**ADDENDUM TO THE WORK PLAN FOR  
SOIL AND GROUNDWATER INVESTIGATION**

**ABE PETROLEUM LLC  
17715 Mission Boulevard  
Hayward, California 94541**

**September 10, 2003  
Project 03-103.06**

**Subject: Addendum to the Work Plan for Soil and Groundwater Investigation,  
17715 Mission Boulevard, Hayward, California**

**Expanded Sit Plan**

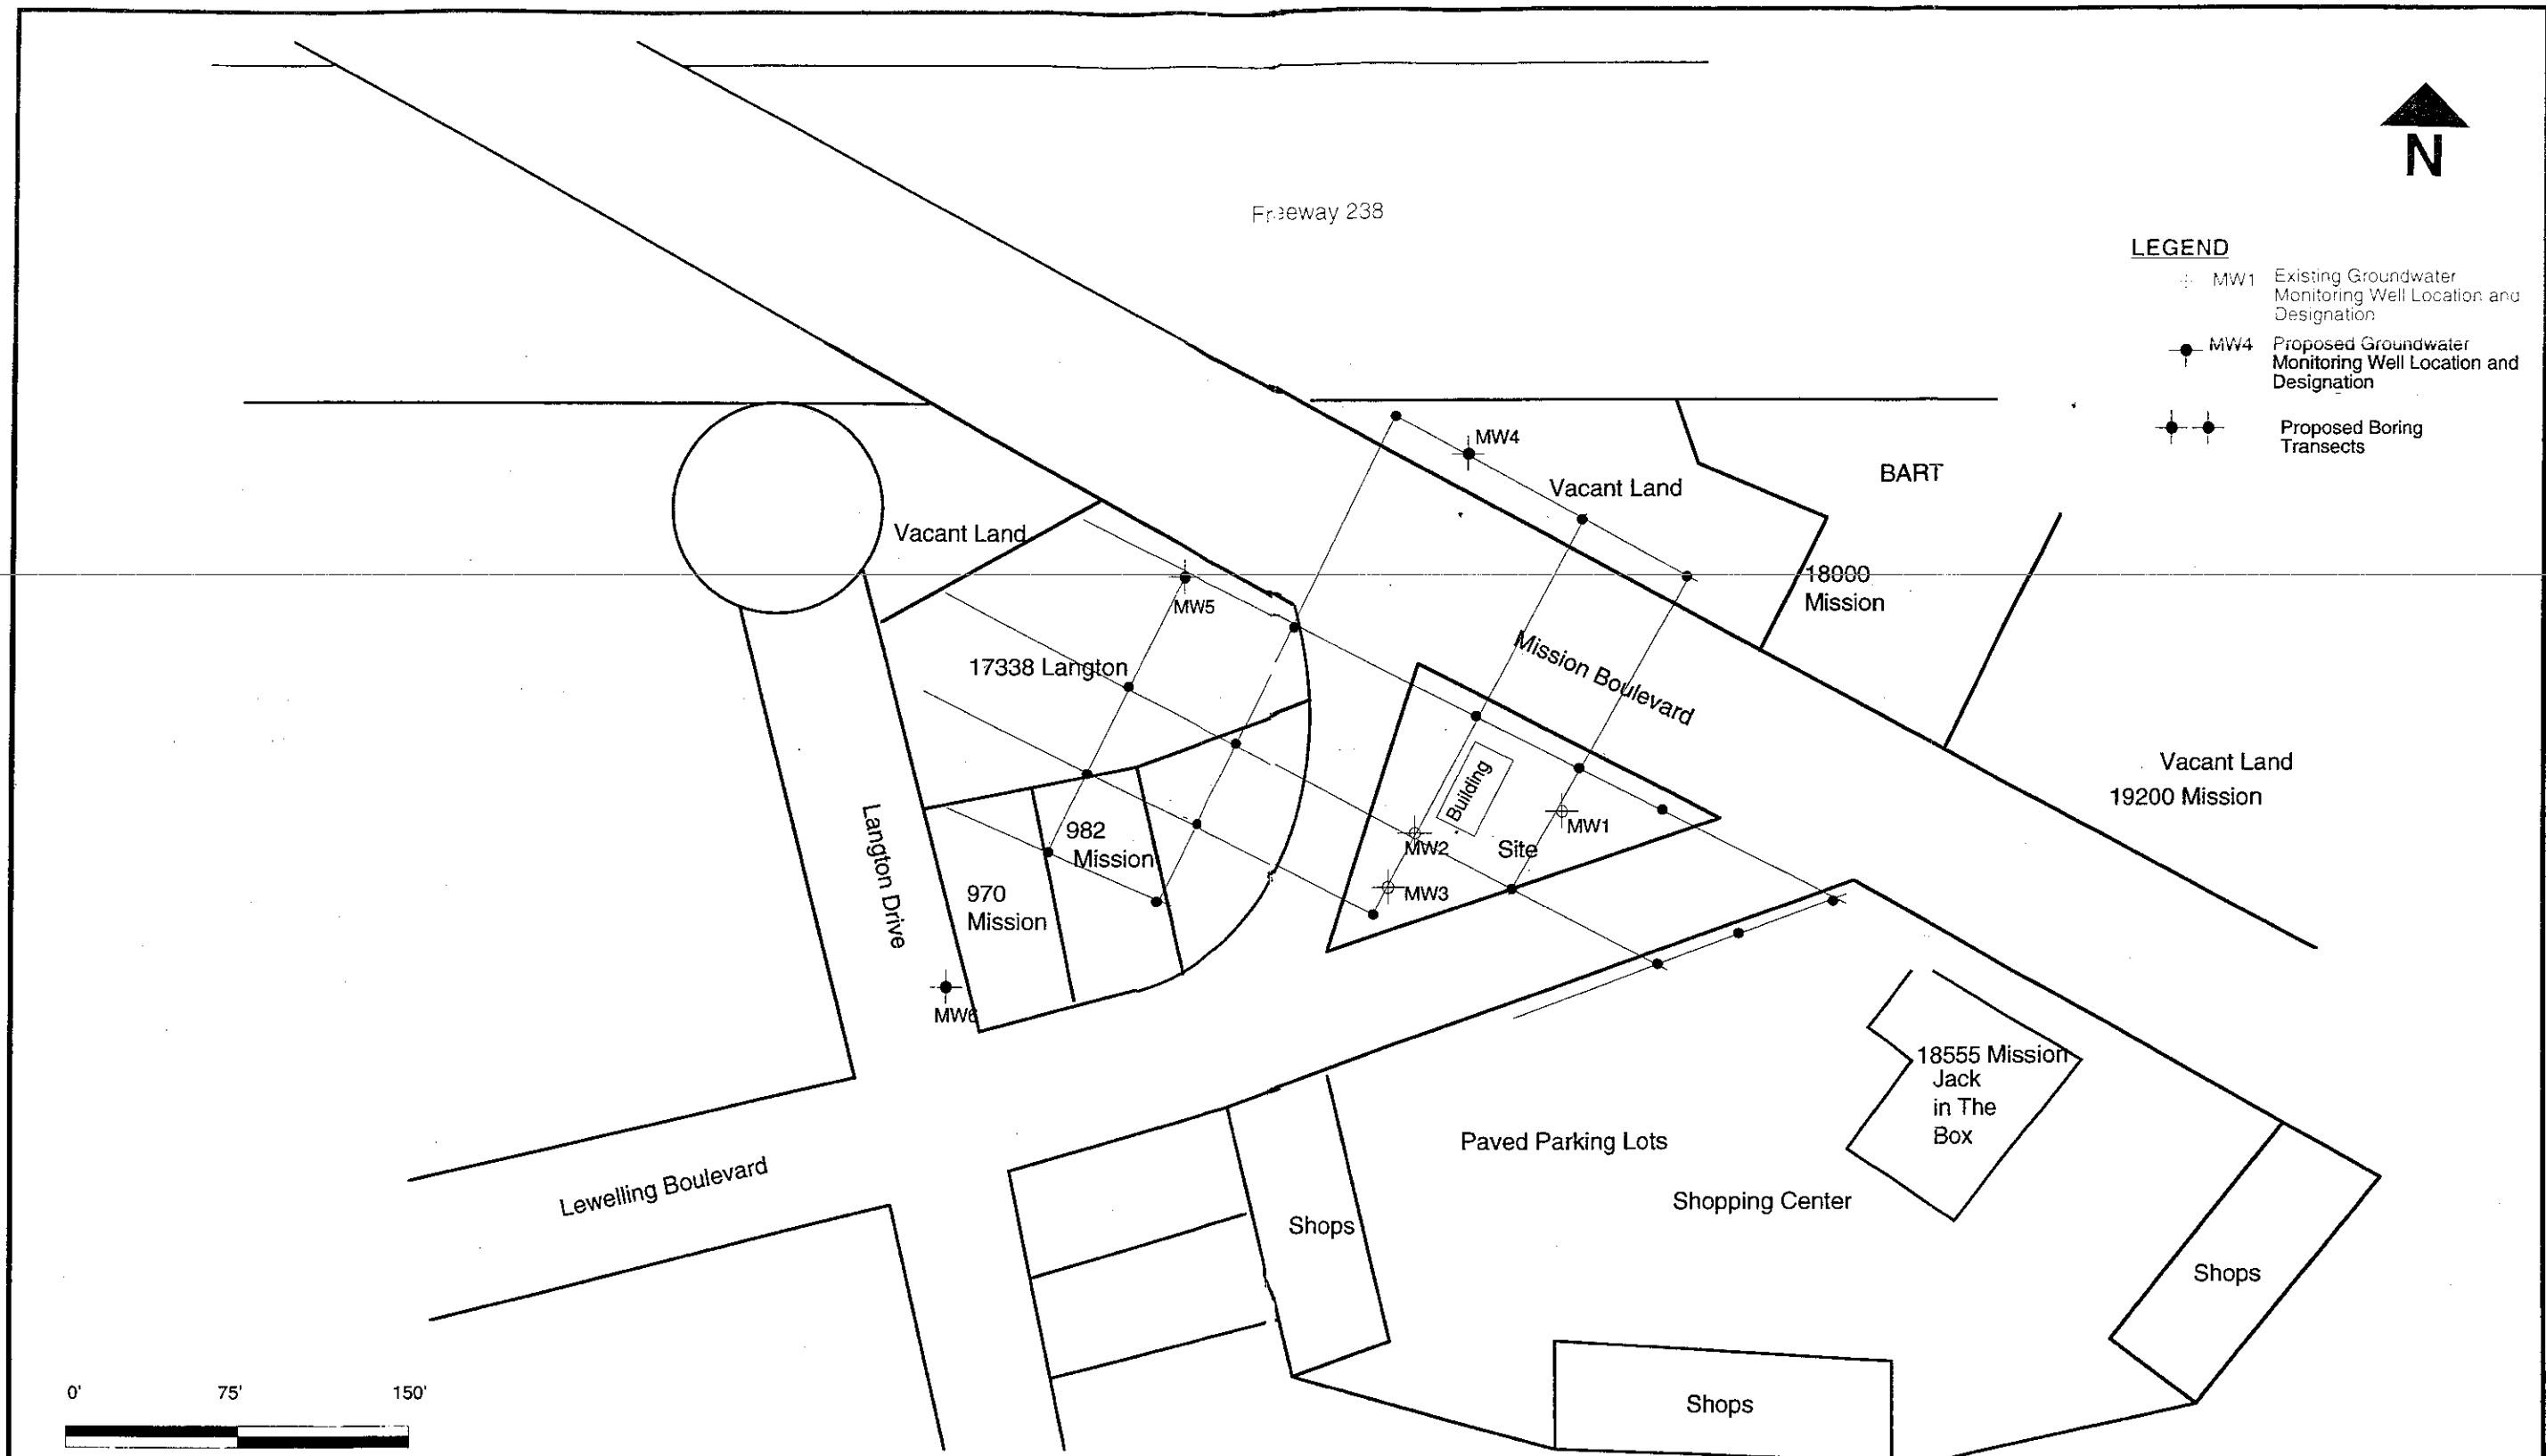
boring drilling program based on the present limited information. Our original work plan proposed six new wells, and we firmly believe that three is the bare minimum that should be installed farther from the site to aid in the determination of the groundwater flow direction in the greater site area. Figure 1 shows the proposed locations of these three wells. The only change in the well installation procedures from our original work plan is that the borings will be sampled at 5-foot intervals, rather than continuous sampling.

As requested by ACHCS, we have designed a tentative grid of boring transects showing proposed locations for 18 exploratory borings (Figure 1). Because the groundwater flow direction is uncertain, Mission Boulevard is the principal feature governing the orientation of the grid, but the grid could be rotated by several degrees if necessary after Task 1 has been completed to more closely match the flow direction. The average spacing between borings is about 35 feet, except where the transects cross various streets. Several borings would be located on private properties, and it would be necessary to secure permission from the various property owners before drilling could be performed. It might be necessary to adjust some locations if property owners and/or access restrictions prevent the grid from being drilled as shown. The drilling program would encompass the following subtasks:

To better characterize the vertical stratigraphy, we propose to continuously sample 3 of the 18 proposed borings. One of these borings will be located on the site, another will be located in the vacant lot north of Mission Boulevard, and the third will be located at the most convenient location south of MW5 (Figure 1). If sufficient room is available, a cone-penetrator rig will be used, but if access is limited, either a conventional hollow-stem auger rig or a Geoprobe- rig may be required. This will be determined in consultation with potential drilling subcontractors, after property owners have been contacted for permission to drill. The core samples will be preserved in labeled core boxes for later detailed description and photography by a registered geologist.
